**RE: Barton Mines Company, LLC
Ruby Mountain Garnet Mine
Major Permit Modification
NYSDEC Mine Permit #5-5230-00002/00002 (Mine File #50483)
APA Permit #: P79-140, P70-356, P87-39, P87-39A, P87-39B, P88-393, P88-393A**

On behalf of Barton Mines Company, LLC (Barton), Bowman Consulting Group (Bowman) has prepared this document in response to comments from the New York State Department of Environmental Conservation (NYSDEC) and the Adirondack Park Agency (APA) associated with the permit modification application referenced above.

GW Map 2. Groundwater Contour Map – Plan View (Sheet 1 of 2)

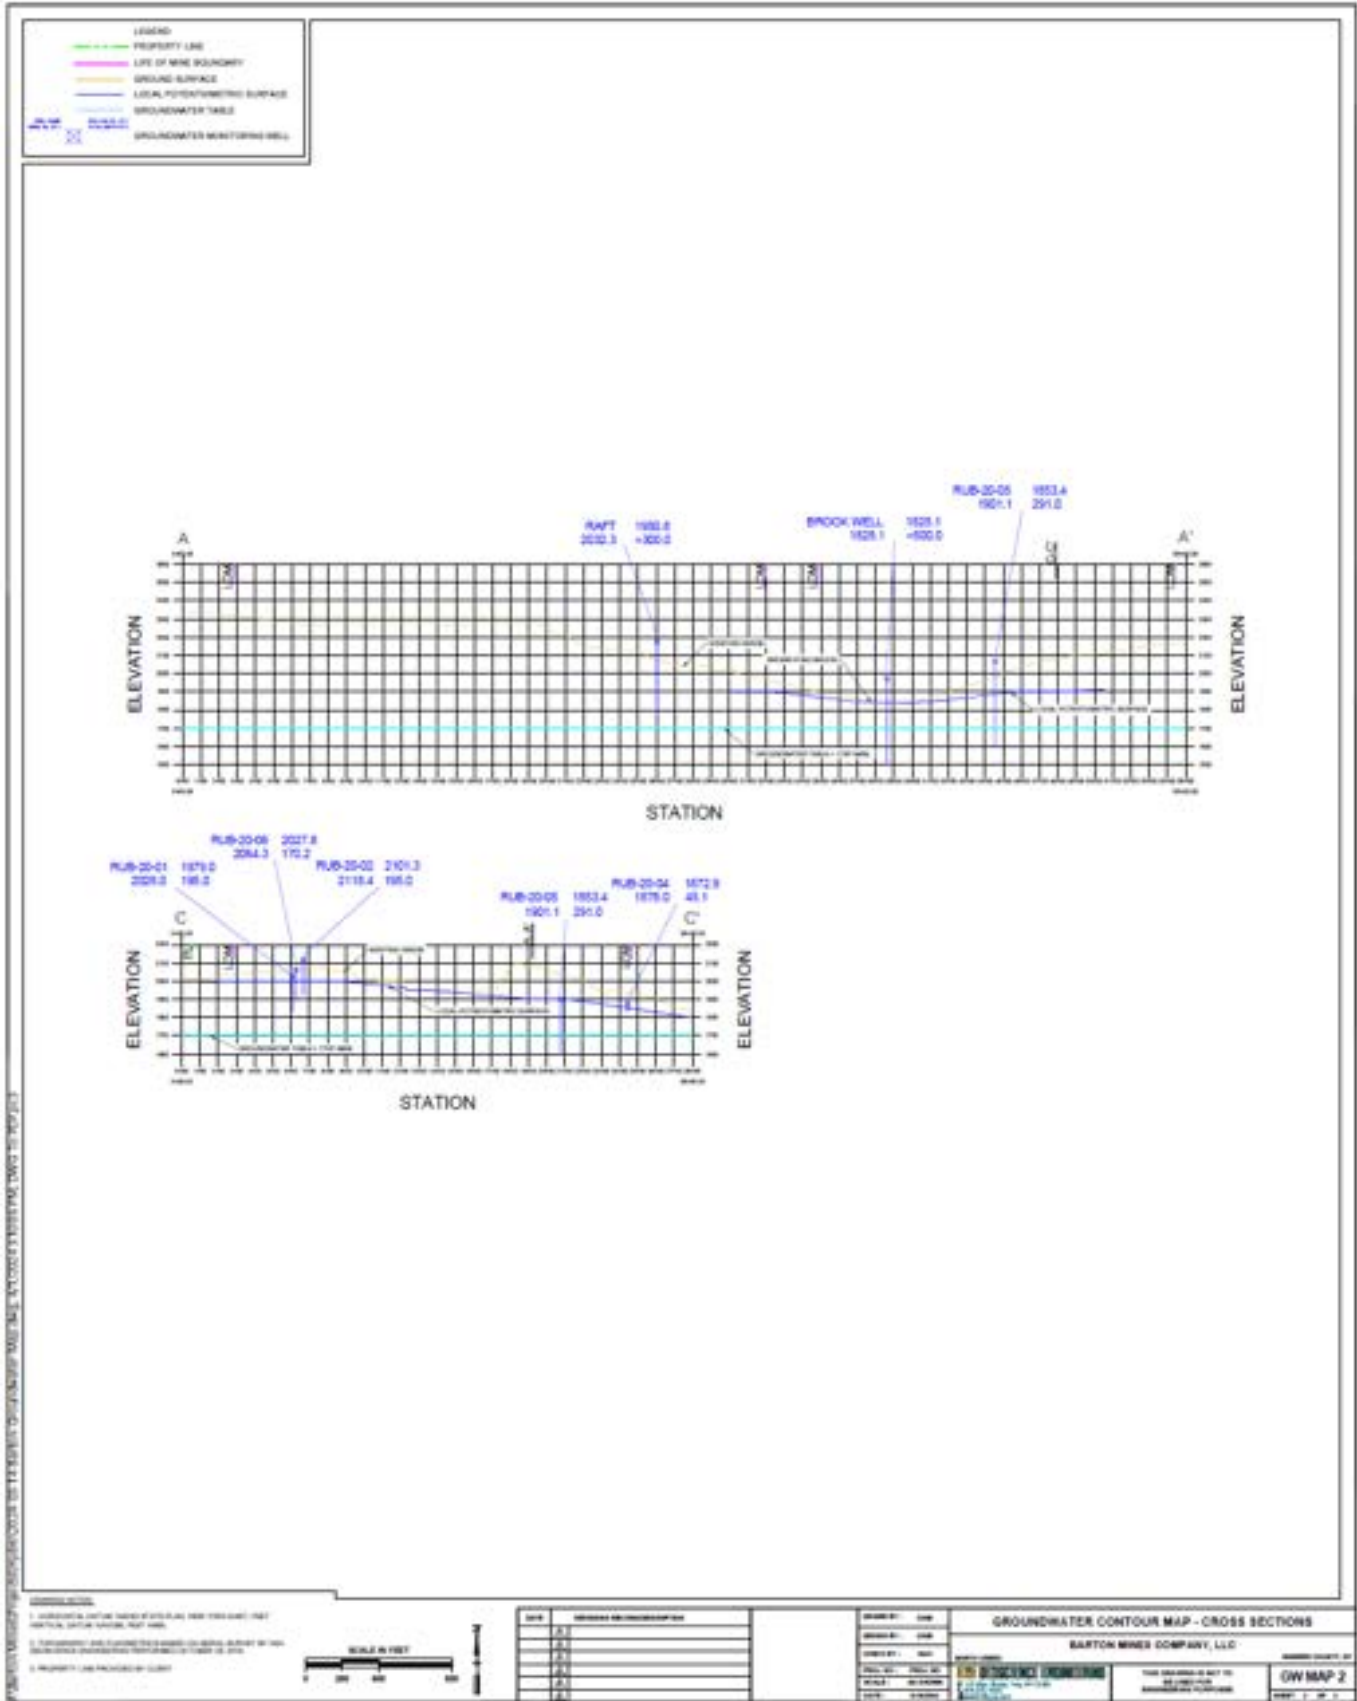
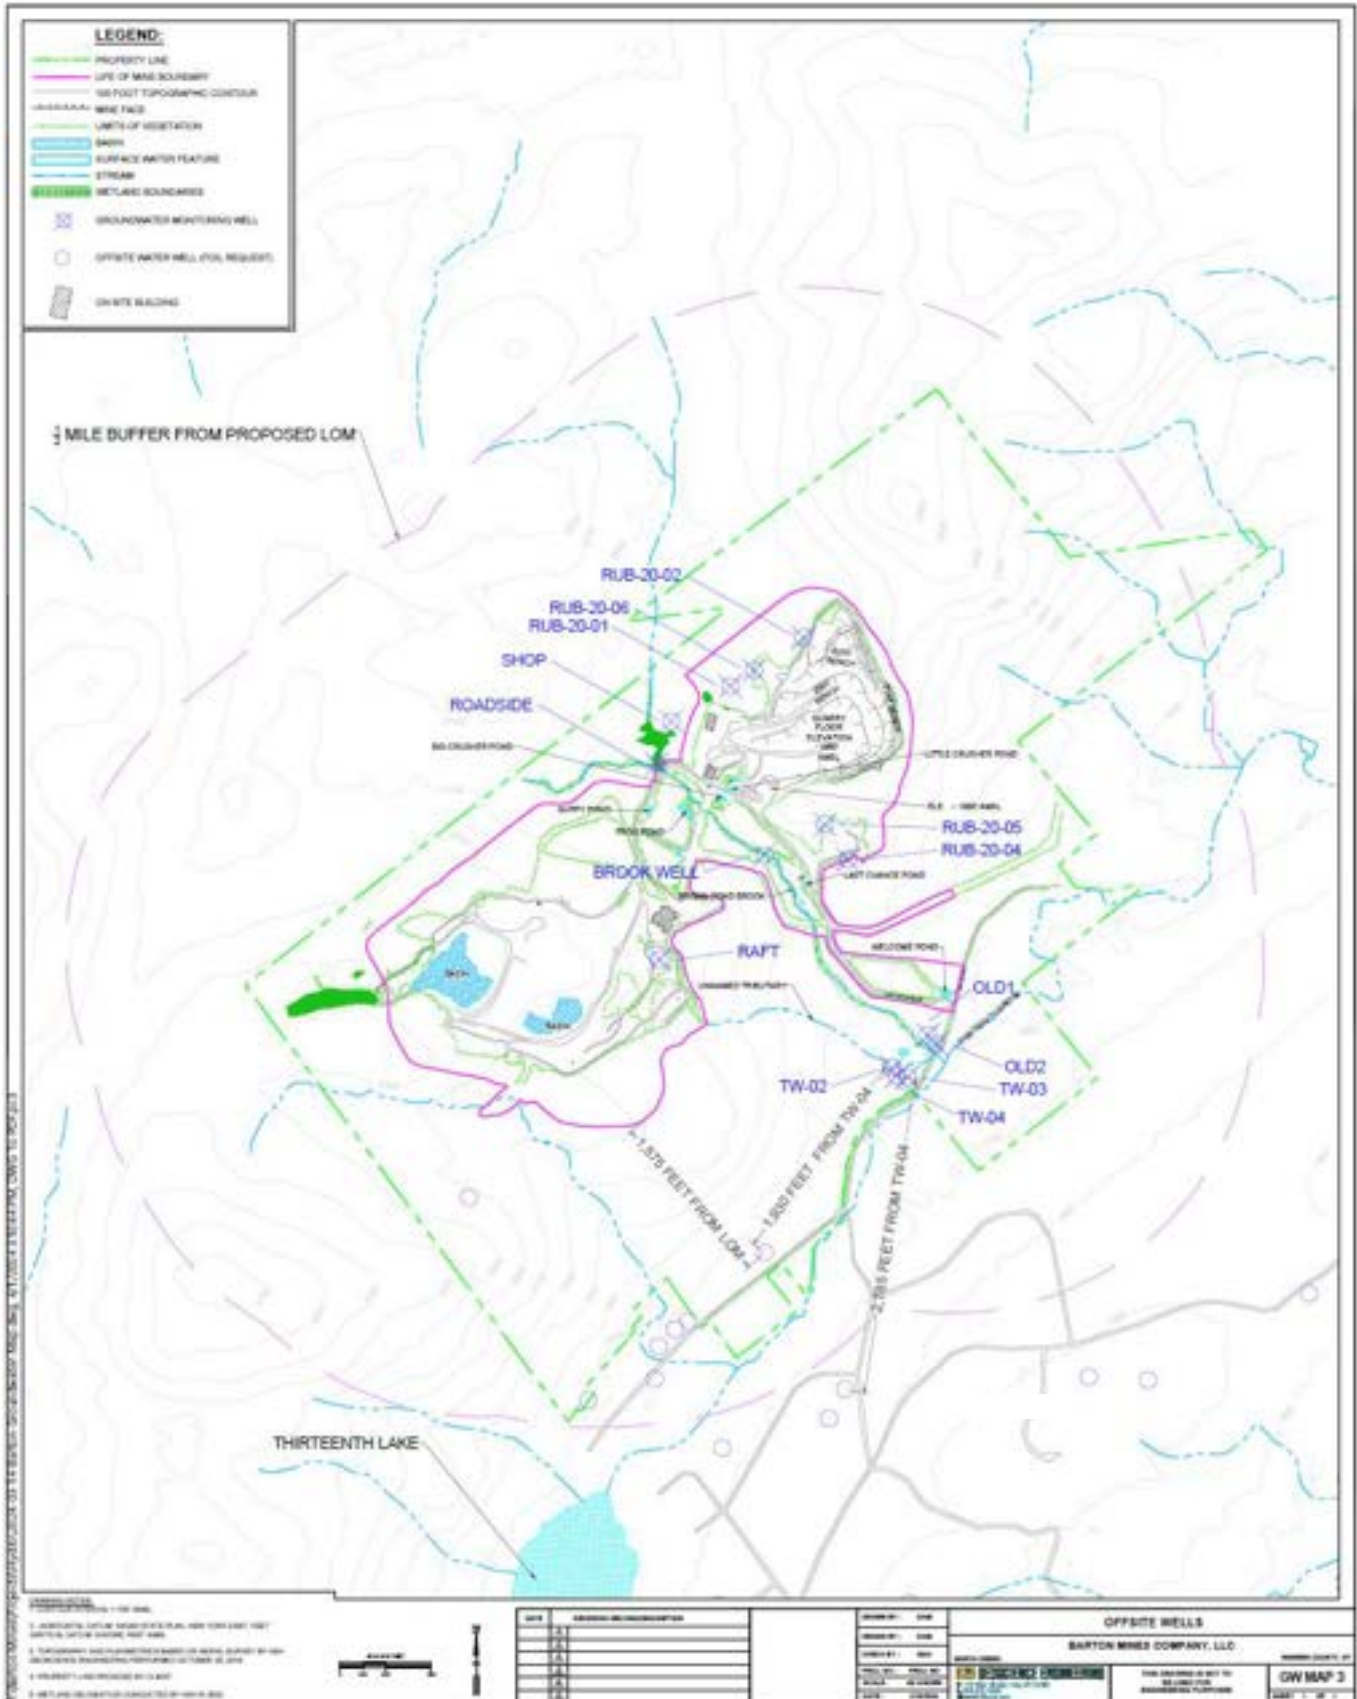
- 2.) **Groundwater: The response to item number 13 and 14 of the letter states that well locations have been included on the cross-sections. Please provide these updated cross sections. The response to item number 13 and 14 of the letter states that well locations have been included on the cross-sections. Please provide these updated cross sections. The groundwater elevation provided on the cross sections is 1700 feet AMSL throughout the entire site. Is this an accurate representation of the groundwater elevation provided by monitoring wells? Monitoring location RUB-1 indicates a groundwater elevation of 1982 feet, monitoring location RUB-6 indicates a groundwater elevation of 2,023ft, RUB-2 shows groundwater at elevation 2,104ft. The groundwater elevation indicated on the cross sections should reflect the groundwater elevation indicated by the map on page 10 of the narrative and the well data.**

Response: The cross sections have been updated as requested. All groundwater elevation information presented on the updated cross sections has been validated.
